Planning and Zoning Board

April 7, 2021 Agenda Supplement

SUBJECT: Southern Palms Car Wash and Heartland Dental Office Building Site Plan Applications.

**AGENDA ITEM STAFF SUMMARY:
Southern Palms Carwash Site Plan Review**

Groves Town Center Conceptual Master Plan (Current)

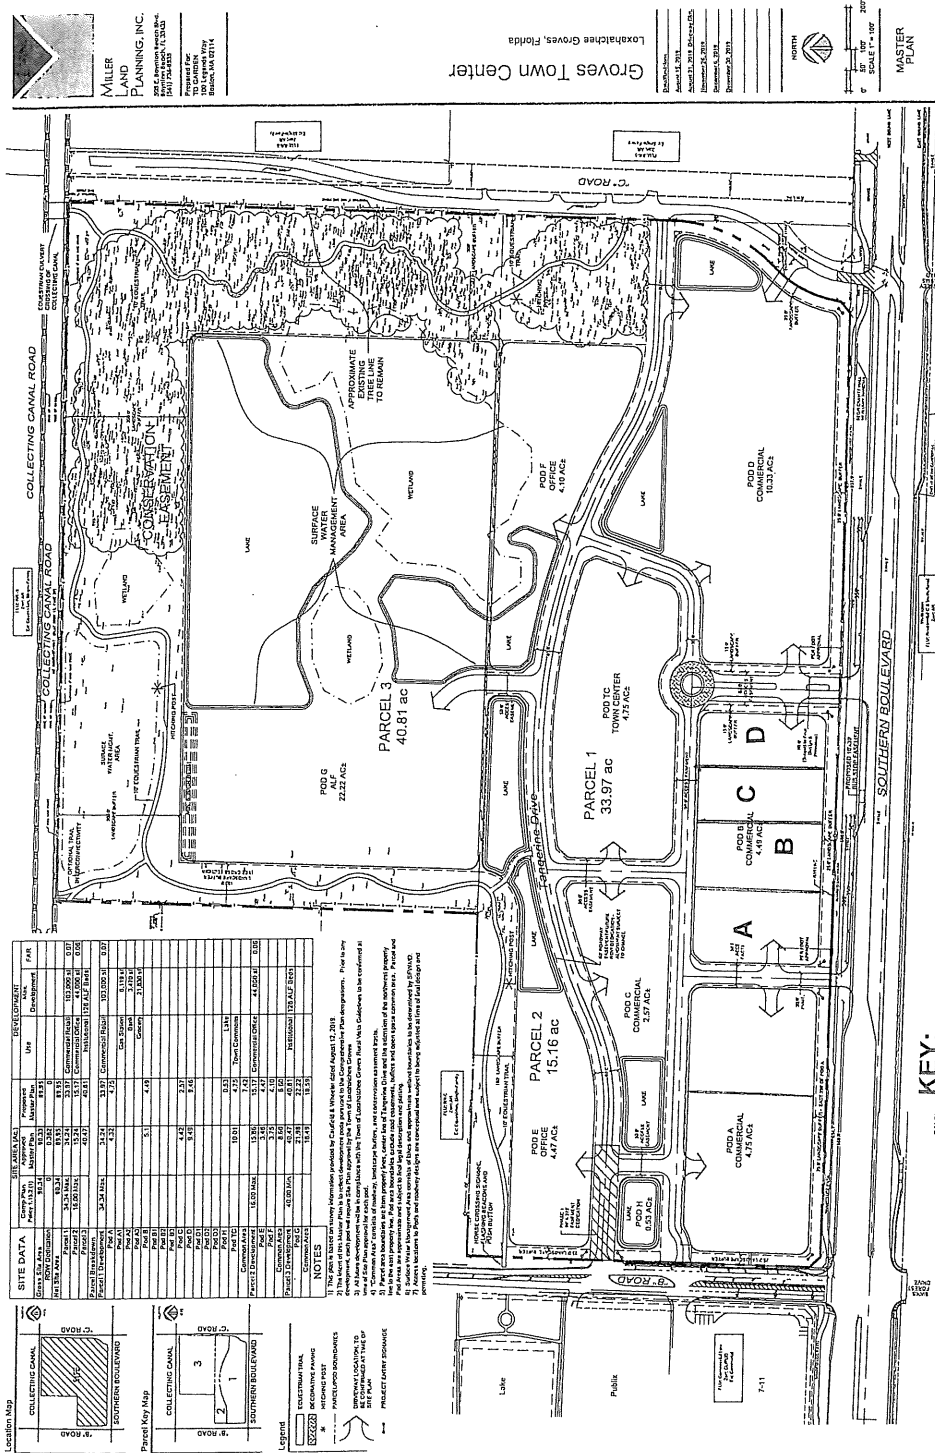
The Conceptual Master Plan, most recently revised by Ordinance 2019-08, includes several Development Pods. The 1.05 acre Subject Site is located within the 4.98 Pod B which is designated for commercial uses on the Conceptual Master Plan (Ref: ATTACHMENT 1).
